# Access Compliance Report

## Public Rights-of-Way

Intersection ID: 28112	Main Street: PROVIDENCE_RD	Cross Street: BELICOURT_DR	Location: SE
ADA ID: B1413EB04AF4	Ramp Type: Para	Initial Pass/Fail: Fail	Overall Compliance: No
Severity Score: 12.5			
Codes/Mitigation Info/Possible Solution		Field Measurements/Component Compliance

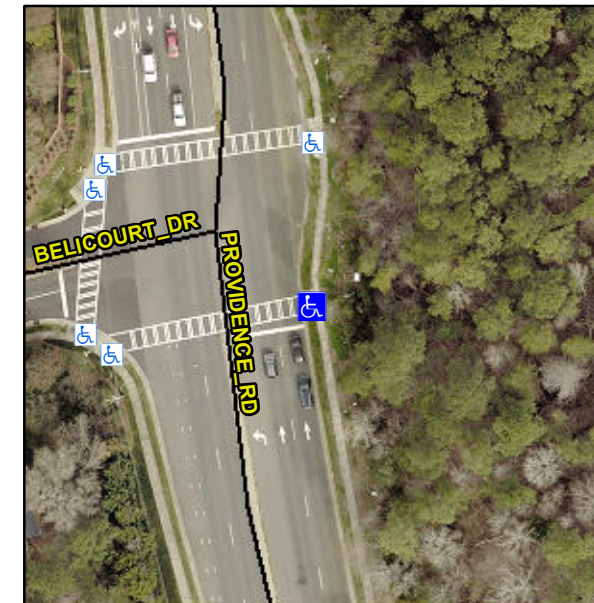
**Remove & Replace Entire Ramp.**

**RT RP < 5%**

**R304.3.2**
